RESPONSE TO REQUEST FOR ADDITIONAL INFORMATION

APR1400 Design Certification

Docket No. 52-046

RAI No.: 239-8076
SRP Section: 16 – Technical Specifications
Application Section: 16.3.3
Date of RAI Issue: 10/09/2015

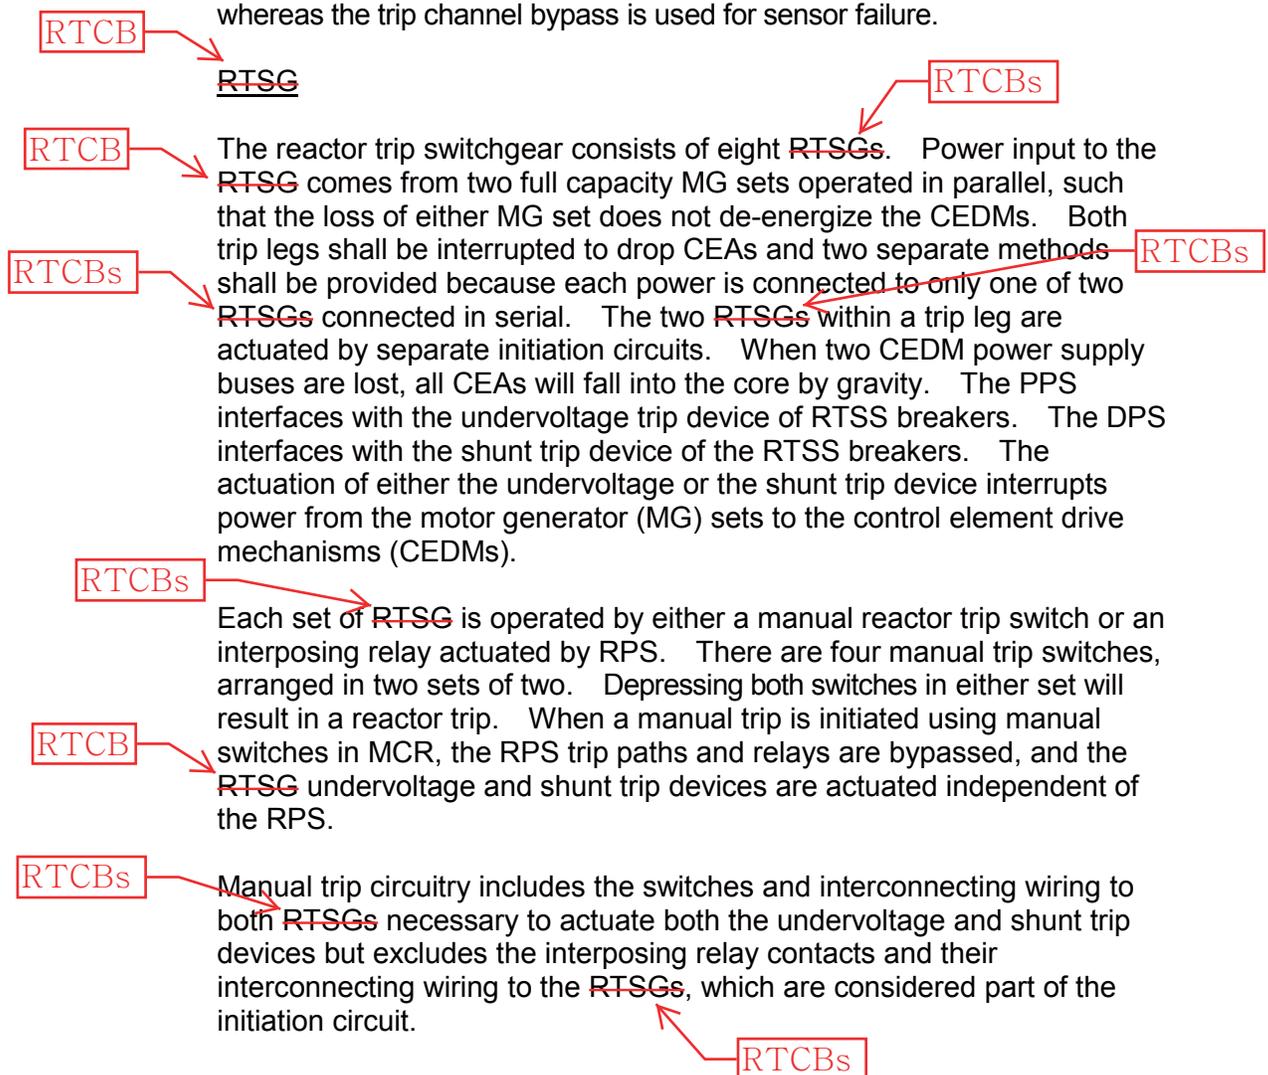
The RPS initiation logic consists of an "OR" circuit for each undervoltage and de-energizes interposing relays. Each interposing relay opens one ~~switchgear in RTSG~~ in turn.

← breaker in RTCB
